Attachment A – Responses to Questions in February 26, 2024 AIR

**Re: Thompson Falls Hydroelectric Project, FERC Project No. 1869-066;
Request for Review and Comment on Final License Application**

Attachment J – Technical Memorandum Conceptual Modifications, Upstream Fish Passage Facility

Figure A-1: Thompson Falls FERC License APE, west end. Red line identifies Lolo National Forest boundary.

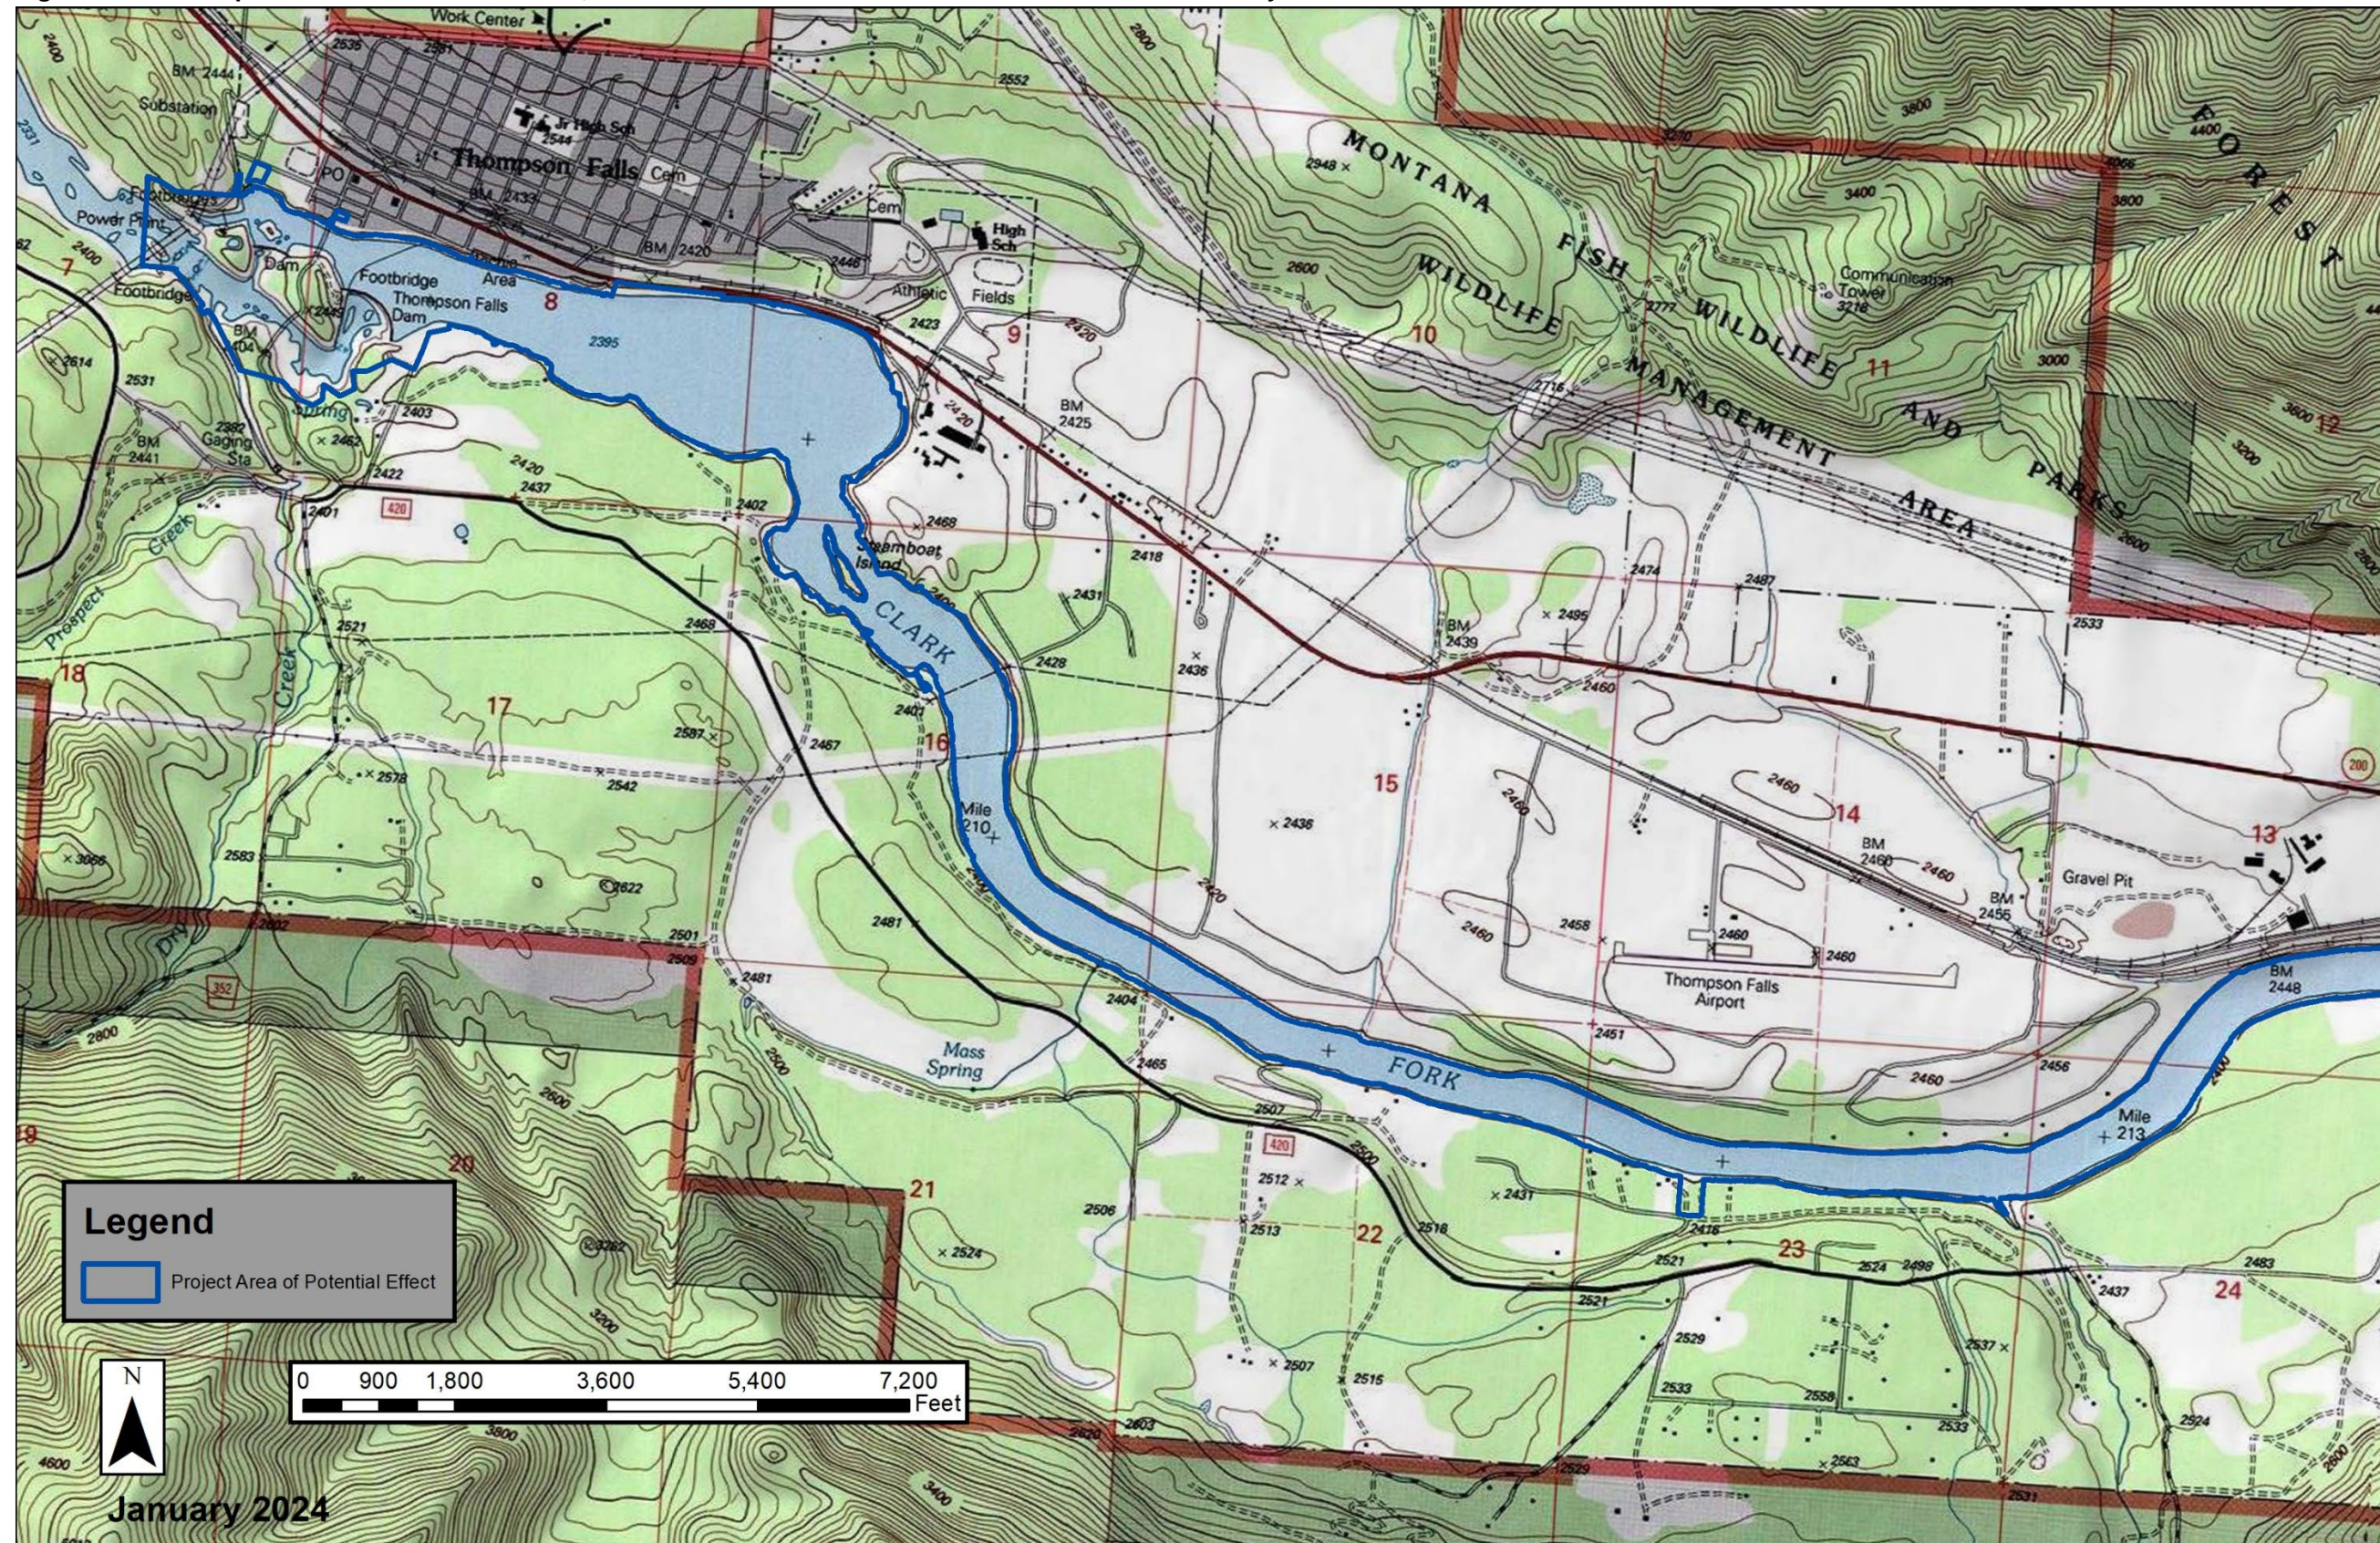
Request: Section 12.4.2 of Exhibit E states that a “new” Area of Potential Effect (APE) is proposed based on your project boundary modifications. Your responses to comments in Table 19-2 in Exhibit E states that the Montana State Historic Preservation Officer (Montana SHPO) concurred with the “new” APE on December 20, 2023. In section 2.4 of the revised Historic Properties Management Plan (HPMP), which was filed as privileged as Appendix F of Exhibit E, you define the APE as “lands within the project boundary as proposed in the relicensing application” which would be 1,536 acres. However, the cultural resources inventory study report filed with the license application indicates the APE as 946.7 acres (see section 2.1 on page 2-1 of the cultural resources inventory study report). Please explain this discrepancy and confirm if there are any areas of the new APE that were not surveyed as part of the cultural resources inventory.

NorthWestern consulted with the State Historic Preservation Office (SHPO) and received concurrence on December 20, 2023 with the Project APE included in the Final License Application filed with FERC on December 29, 2023. The proposed change to the Project Boundary also changes the Project APE as documented in the Historic Properties Management Plan (HPMP). NorthWestern produced the two attached maps representing the updated Project Boundary and Project APE. These updated maps will replace the Project APE maps included in Appendix A of the HPMP.

Figure 2. Alternative 1 Modifications

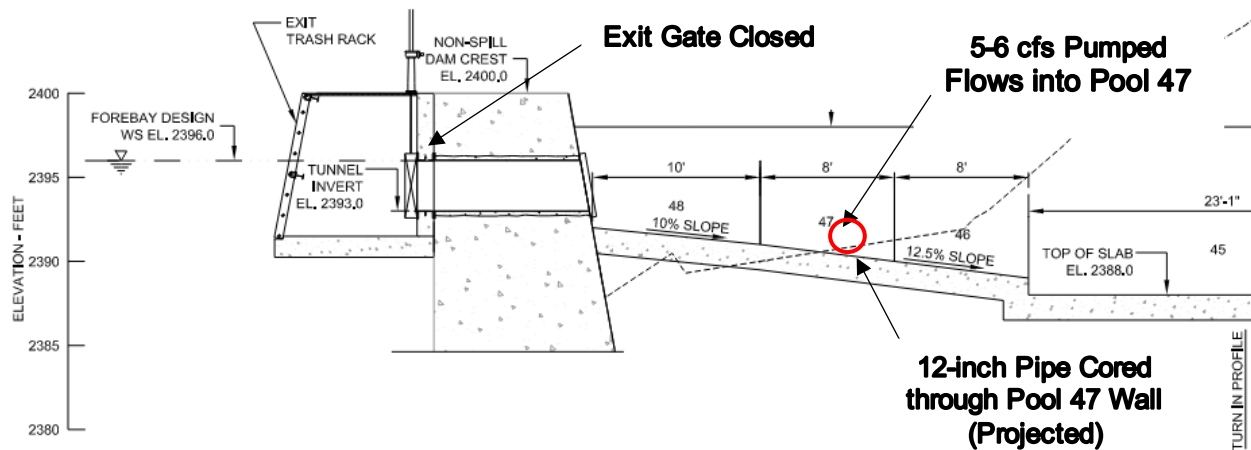
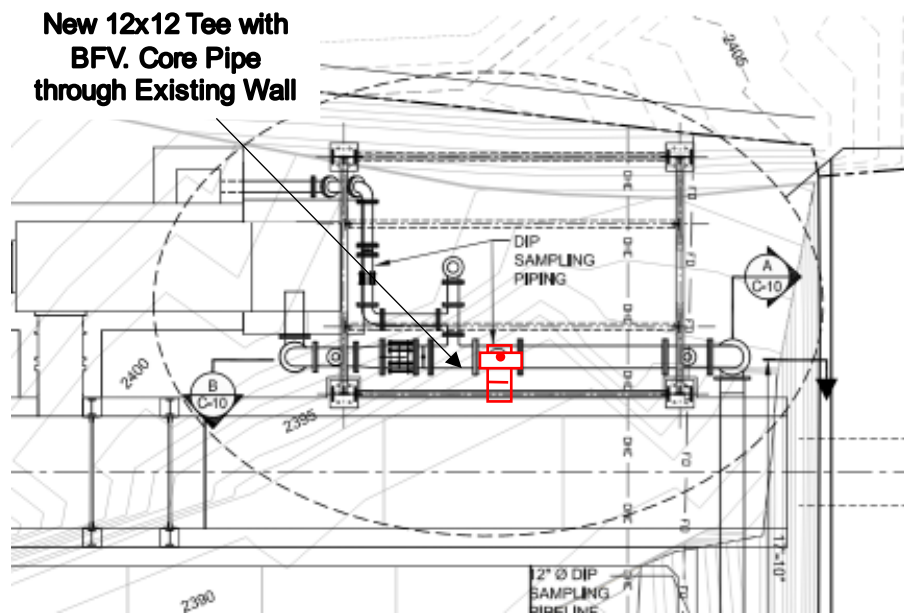
Request: Sections 2.2.4 and 7.2.2 of Exhibit E states that you propose to develop “an engineered solution to provide adequate flow to the upstream fish passage facility at all water surface elevations down to 2.5 feet below full pool. This work will be completed prior to NorthWestern’s implementation of flexible generation between 2.0-2.5 feet below full pool during periods when the fish passage facility is operating.” This measure is too vague for staff to evaluate. Please identify what conceptual “engineering solution” options are being considered for maintaining adequate flow to the upstream fish passage facility under your proposed operation as well as their associated costs.

This option includes providing a pump to discharge water into Pool 47 or 48. Modifications to the ladder would include:

- Screened pumped intake from forebay with 4000 gpm capacity discharging into Pool 47
- An additional diffuser plate within pool 46 to provide better flow characteristics for Pool 45 (sampling loop entrance).
- A fish screen near the orifice plate in Pool 48 to prevent handled fish from entering Pool 47
- A 12-inch tap and tee with butterfly valve (BFV) through the Pool 47 concrete wall to connect to the AWS Sample Loop Pipe for providing horizontal crowder attraction flows (1/2 cfs), vertical lock pump supply flows, and hose bib use for the sampling facilities.

During this operation, the 12-inch AWS Sampling Loop gate and 42-inch Ladder Exit Gate would be closed as water is pumped into Pool 47. Fish sampling would occur under existing sampling protocol, with fish being returned directly to the forebay. Figures 2 and 3 show profile and plan schematics of the proposed modifications.
